# PLANNING CLEARANCE

BLDG ADDRESS 740 Kennedy SQ. FT. OF BLDG: 2000<sup>sf</sup>  
 SUBDIVISION Kennedy Subdivision SQ. FT. OF LOT: 11900+  
 FILING # \_\_\_\_\_ BLK # \_\_\_\_\_ LOT # 1 NO. OF FAMILY UNITS: 2  
 TAX SCHEDULE # 2945-114-14-019 NO. OF BUILDINGS ON PARCEL BEFORE THIS  
 PLANNED CONSTRUCTION: None  
 OWNER Paul Quam USE OF EXISTING BUILDINGS:  
James Quam NA  
 ADDRESS 750 Kennedy (742 Kennedy) DESCRIPTION OF WORK AND INTENDED USE:  
 TELEPHONE: \_\_\_\_\_ New Duplex

RE: Planning Clearance for 740 Kennedy issued 12/3/92

RE: 740 Kennedy

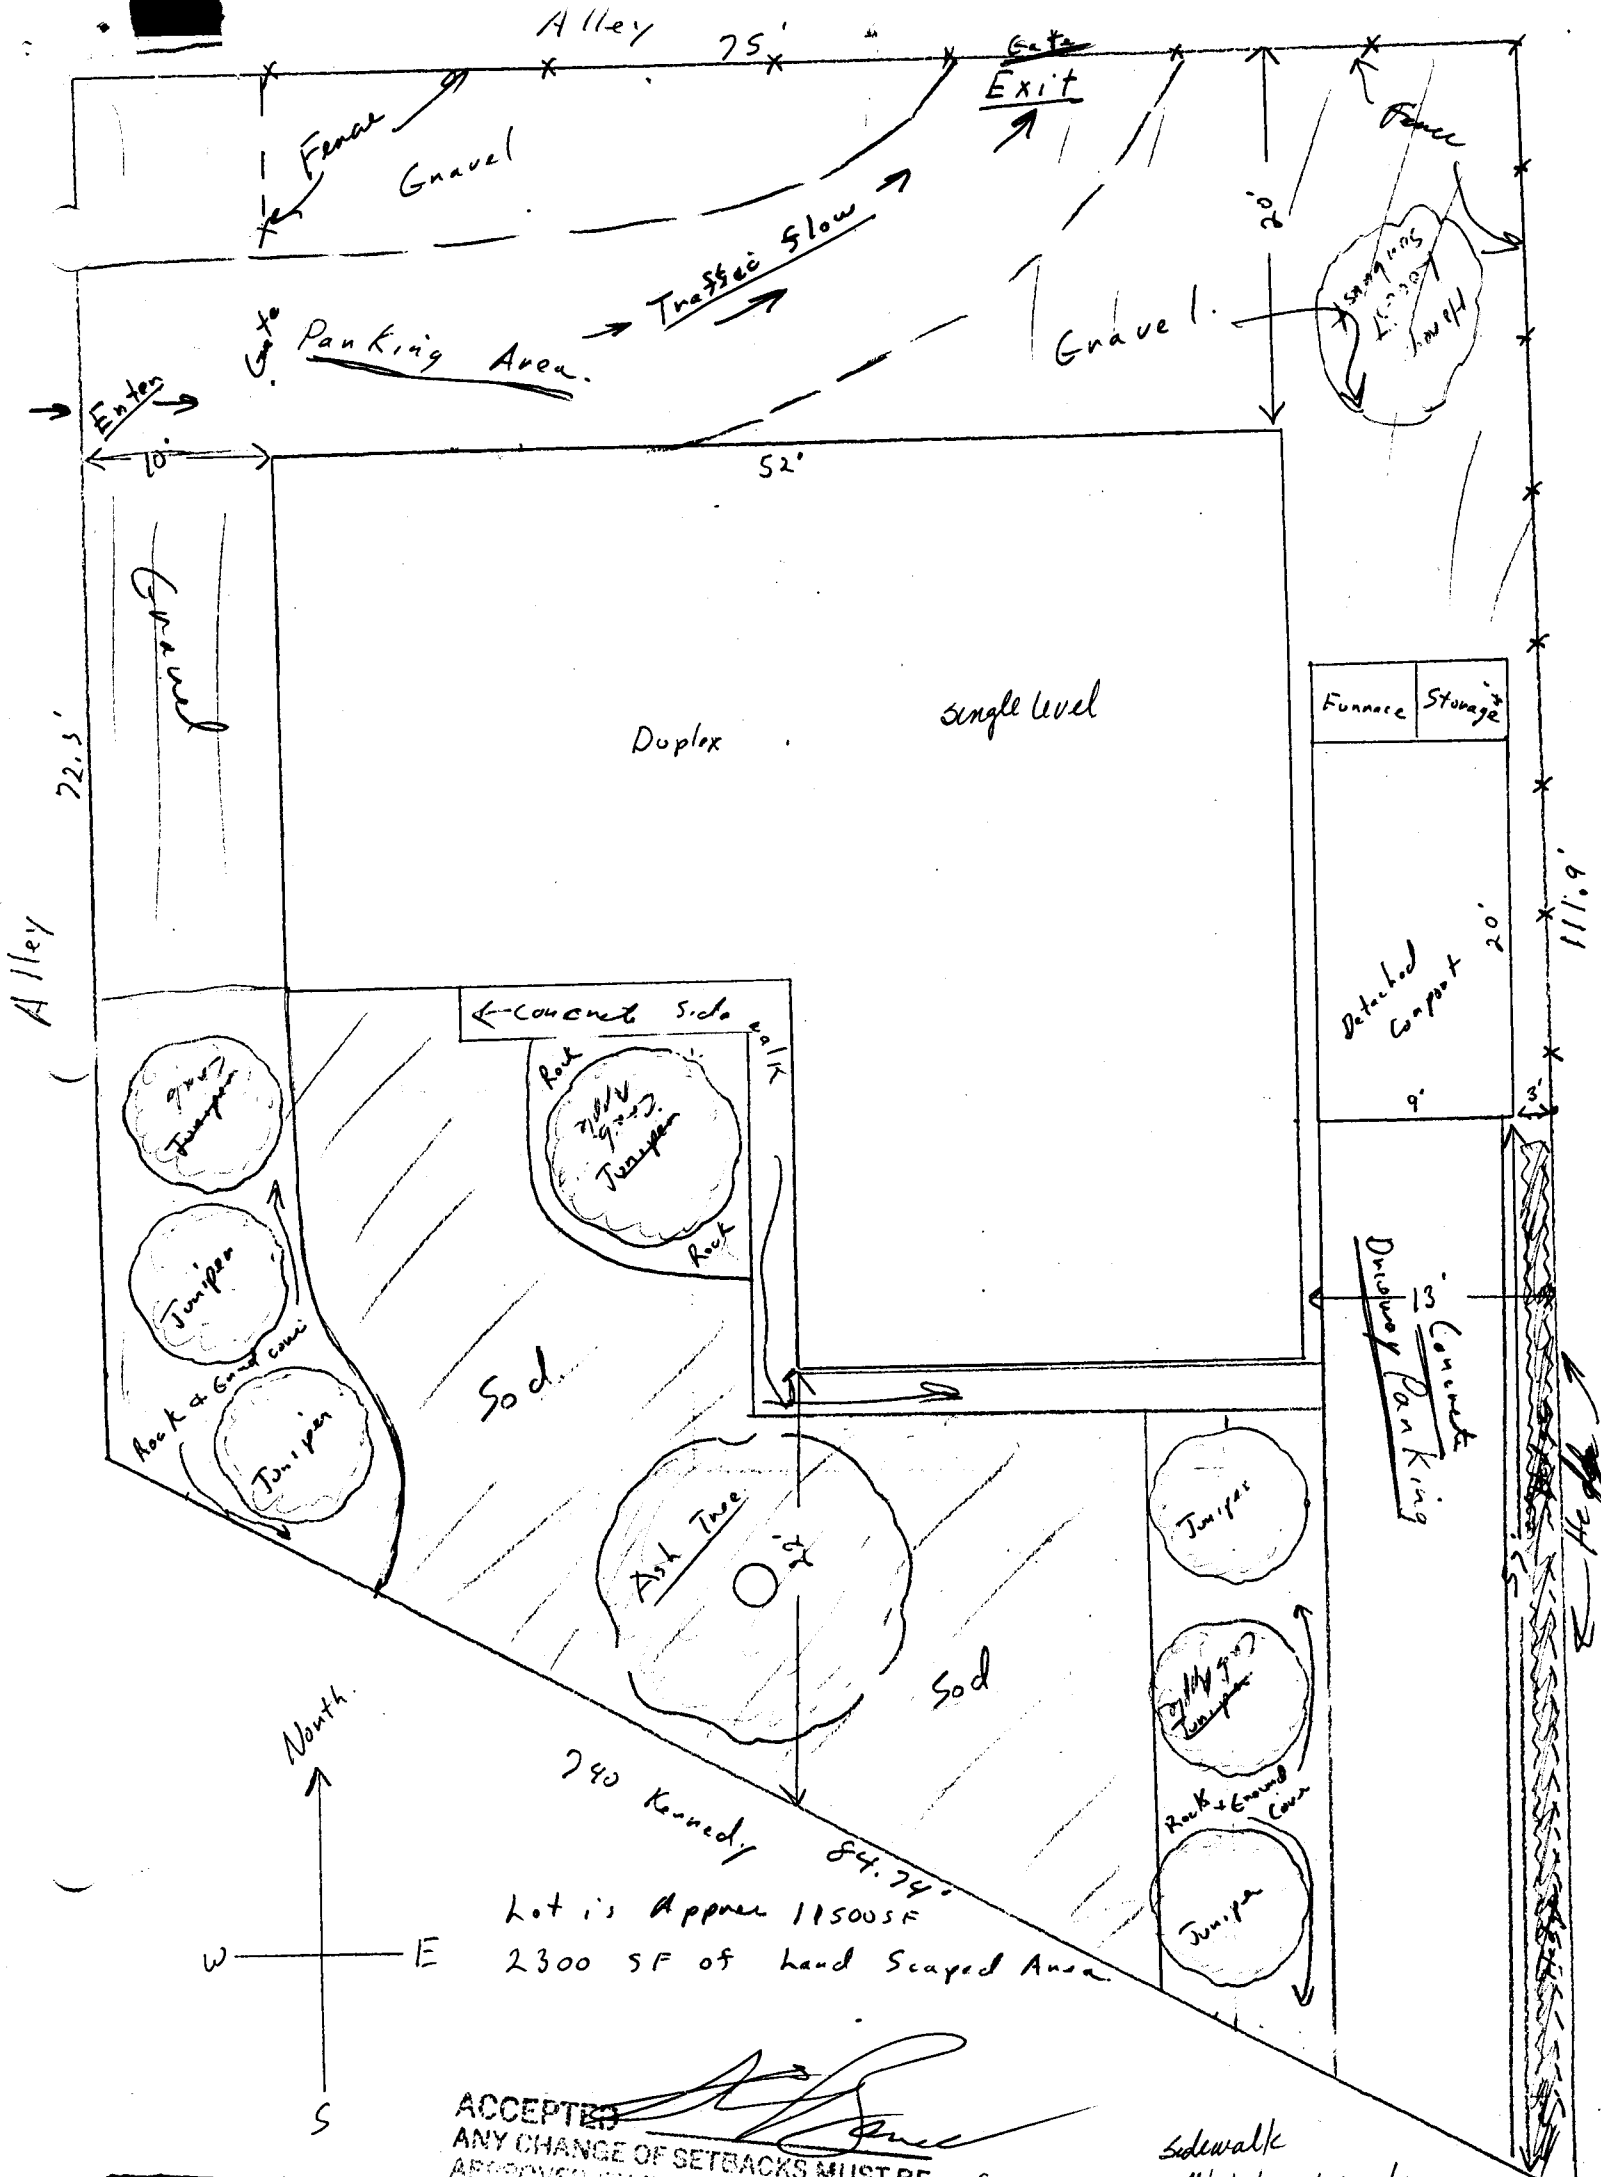
*Outdated*

*Outdated*

Thank you for the parking and landscaping plan submitted for the proposed duplex at 740 Kennedy. The plan submitted and dated December 21, 1992 is the approved site plan for the property. Sidewalk will also be required to be installed along the Kennedy Avenue frontage of the property, built to City standards. Section 5-4-1.E of the Zoning and Development Code states, "The developer of all developments (except for one single family house on a single parcel of land) shall be responsible for one-half road improvements to the center line of all exterior (abutting and not interior) rights-of-way in accordance with Sections 5-4-10, 5-4-11, and 5-4-12". The existing roadway has pavement, curb and gutter but no sidewalk. The sidewalk must be constructed or a guarantee provided for the construction prior to the Certificate of Occupancy being issued for the duplex.

LANDSCAPE DESIGN

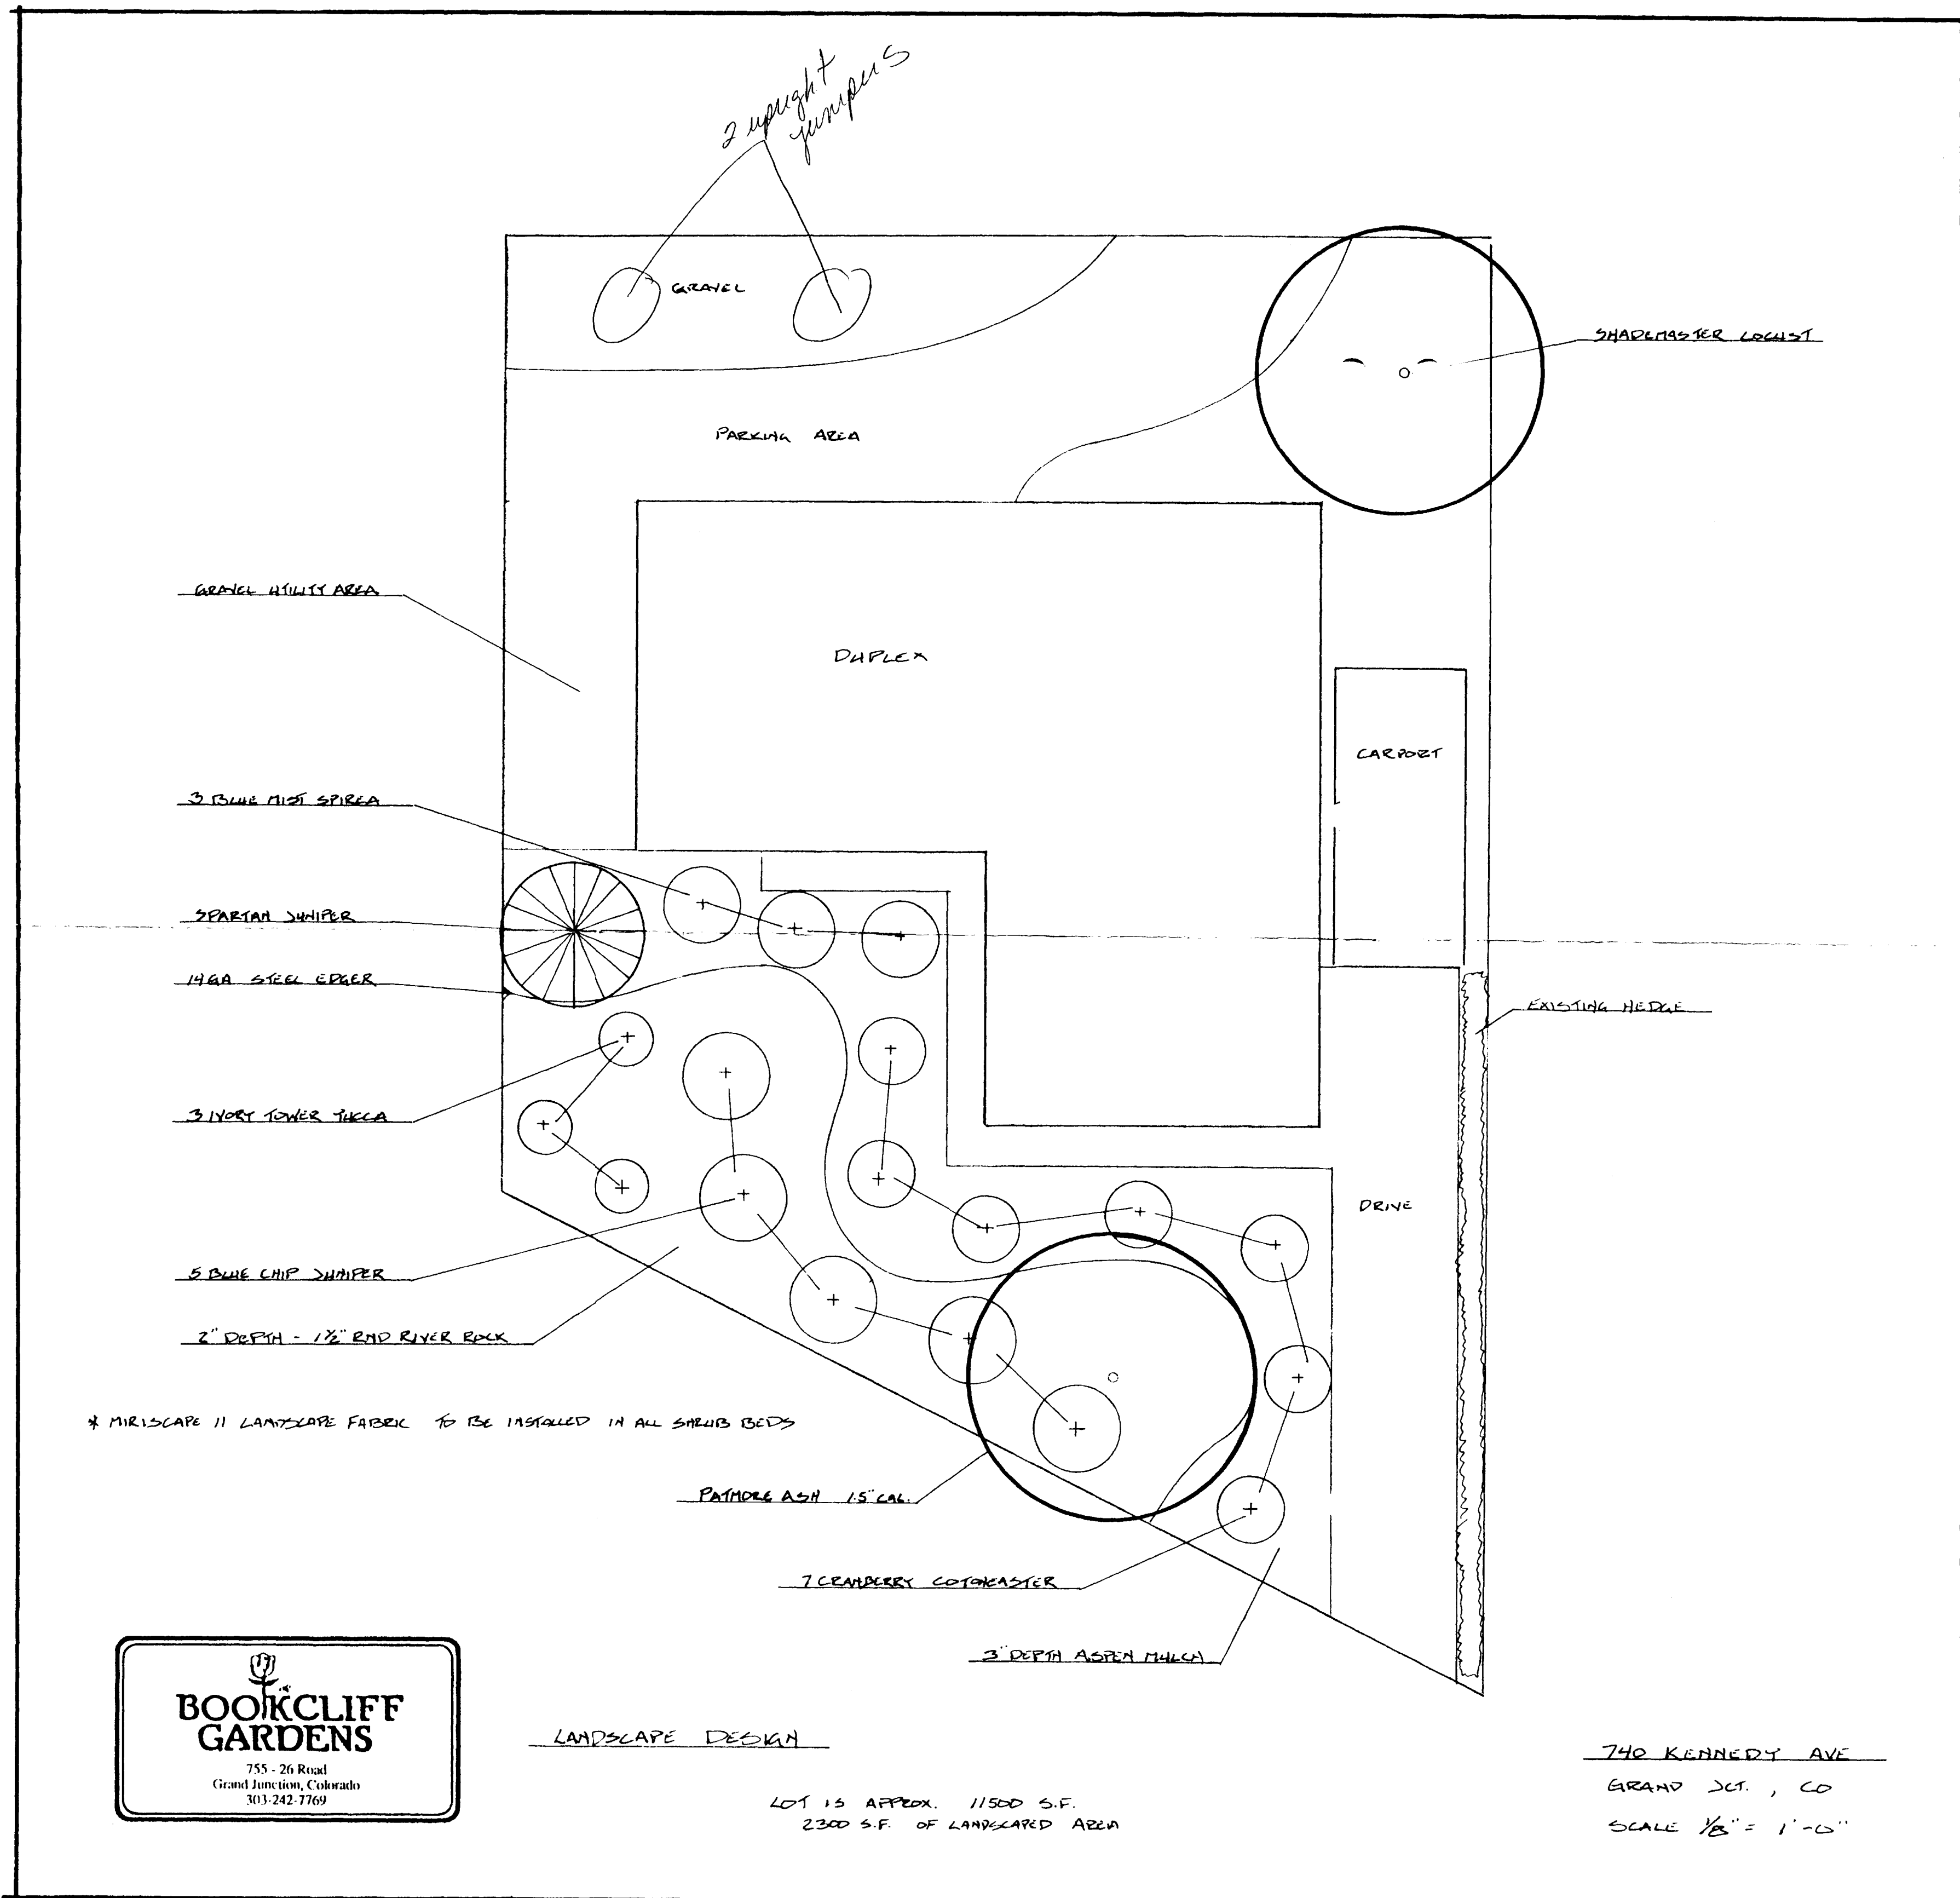
I did a site check of 740 Kennedy yesterday for release of the Certificate of Occupancy (C.O.). I found all the landscaping in the front yard as shown on the approved plan to be in place. However, the 2 upright junipers to be placed between the parking area and north property line (north west corner of the property), agreed upon as an addition to the approved landscaping plan, had not been planted. I spoke to the contractor and he was not aware those were to be added. Rather than hold up the C.O. and the closing to take place the following day, I signed the C.O. with the understanding that the additional trees would be provided.

After looking at the site it seems the two upright junipers may be better placed in the front yard of the units, or perhaps even another shade tree could be installed instead of the two junipers. In either case, please be sure the additional trees are planted by March 31, 1993. Thank you for your cooperation.

As discussed with you and the owners of 740 Kennedy, the landscaping plan prepared by Bookcliff Gardens for the duplex at 740 Kennedy is approved with the addition of 2 upright junipers to be placed between the parking area and north property line. That plan will replace the one previously submitted and dated December 21, 1992. An underground, pressurized irrigation system will also be required.

Revised & accepted plan  
3/1/93  
RD
